Bulletin #: IMCFSM-
 Rev: A
 Pages: 1
 Author: Richard Waters
 Date:
 Affected Models: Chief 2002/03

FSM Bulletin

Speedometer Compatibility

Speedometer Compatibility

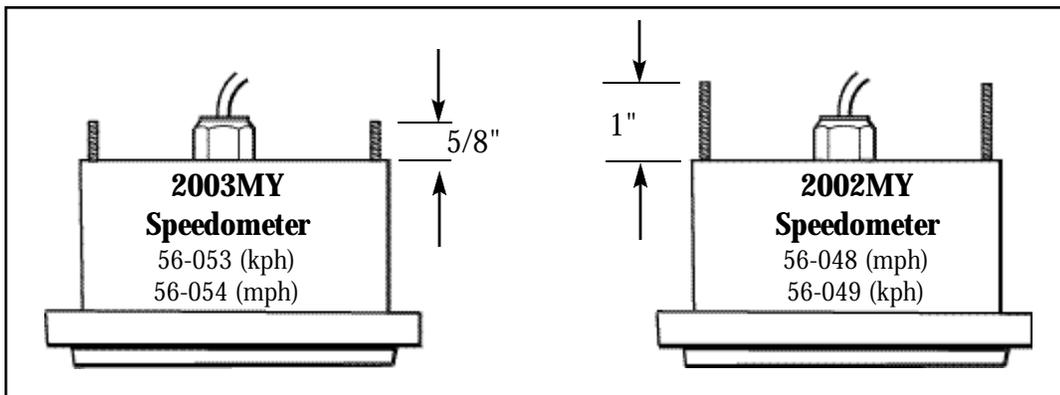
The 2003 Model Year (MY) speedometer (P/N 56-053 & 56-054) & mounting bracket (P/N 56-050) are different from the 2002MY speedometer.

The 2003MY mounting studs on the rear of the speedometer are now shorter, resulting in a reduced height of the mounting bracket (P/N 56-050).

The 2003MY mounting bracket is compatible with both the 2002MY & 2003MY speedometers, but the 2002MY mounting bracket is ONLY compatible with the 2002MY speedometer.

DO NOT over torque the nuts. Over torquing deforms the plastic case and will allow water to leak into the speedometer. Torque the nuts to 5-1/2 **inch-pounds** +/- 1/2.
